21 01 97 (251)

Clutch diagnostics

All models with manual transmission

1 - Embossed stamp

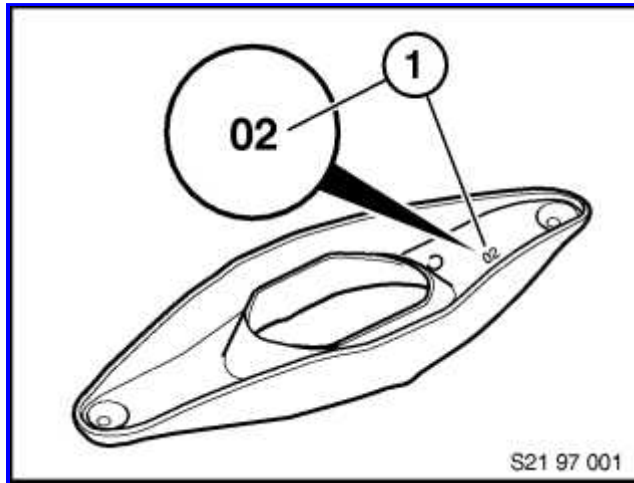
In addition since January 1997 an optimised release lever is installed in the series (all models). This can be recognised by an embossed stamp on the inside.
